Proposal Request

PROJECT: *(name and address)*
AWSOM
Bentonville, Arkansas

PROPOSAL REQUEST 087

Revisions to Gym 1410 Ceiling

1 FIRE PROTECTION - LEVEL 1 RCP - AREA B
1/8" = 1'-0"
SCALE: 1/8"=1'-0"

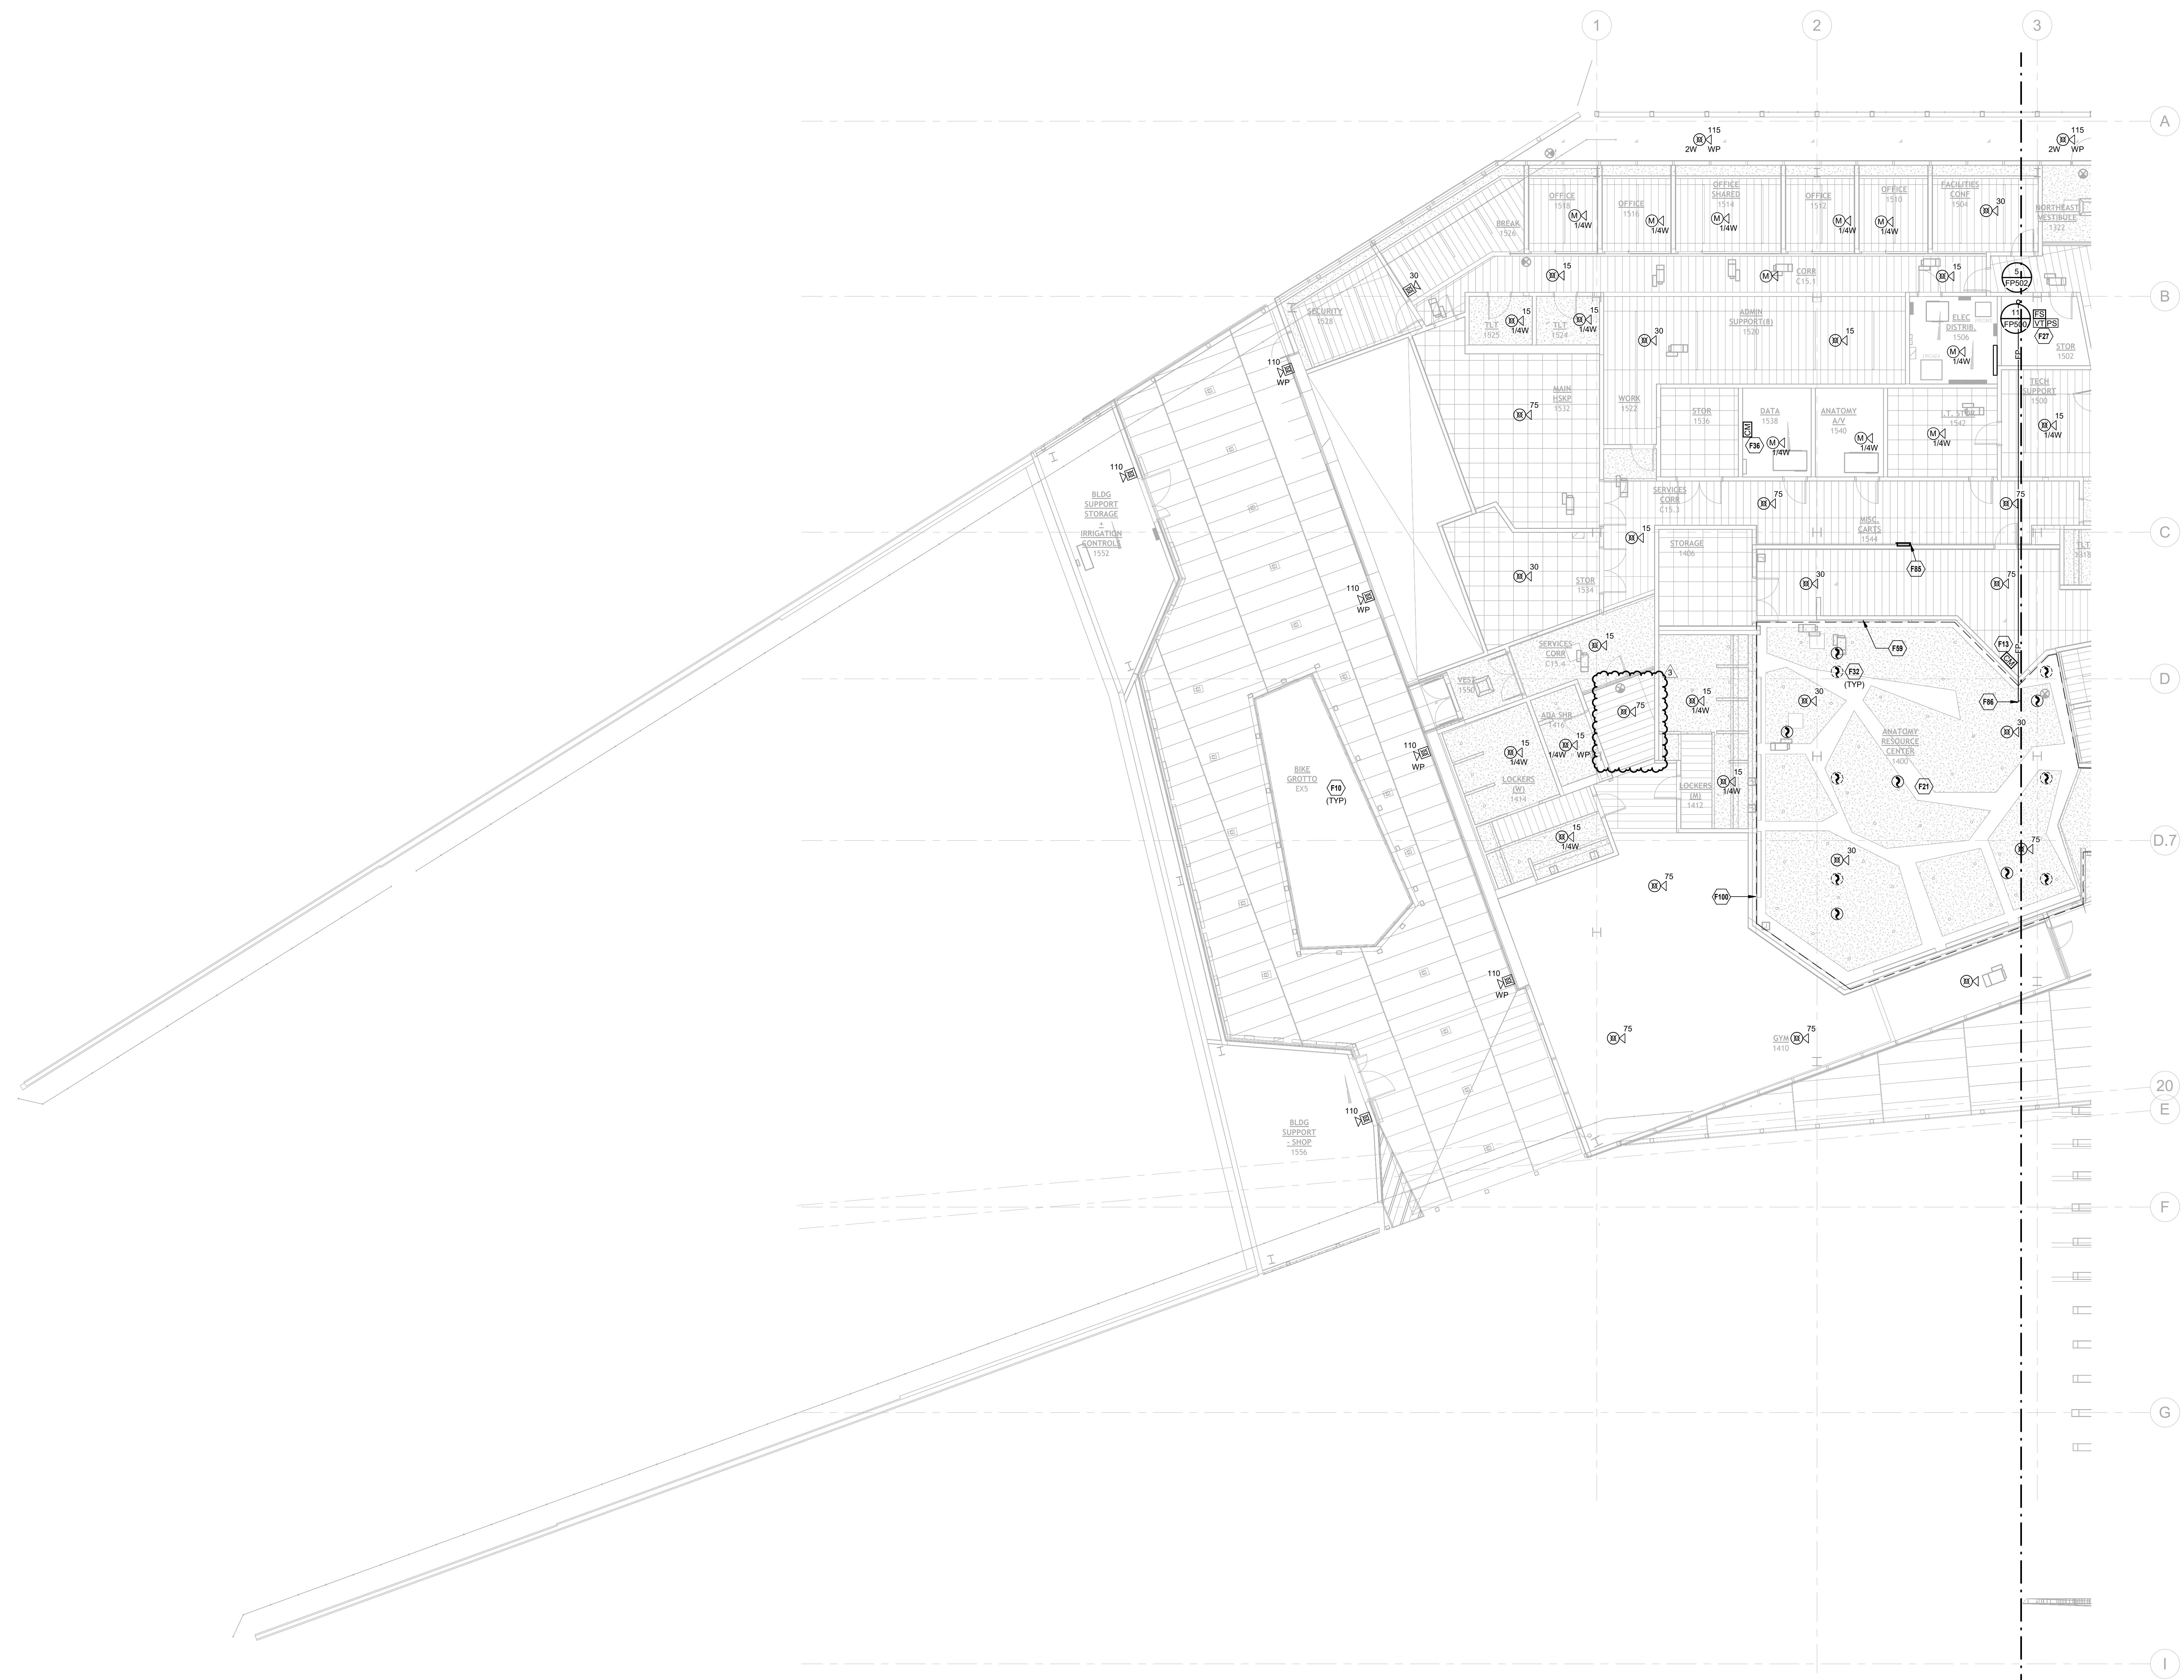
- a) Refer to Sheet **FP101B** with original issue date 02.24.2023 and revised date 10.24.2024.
- Revised location of notification appliance in services corridor plan north 5 feet.
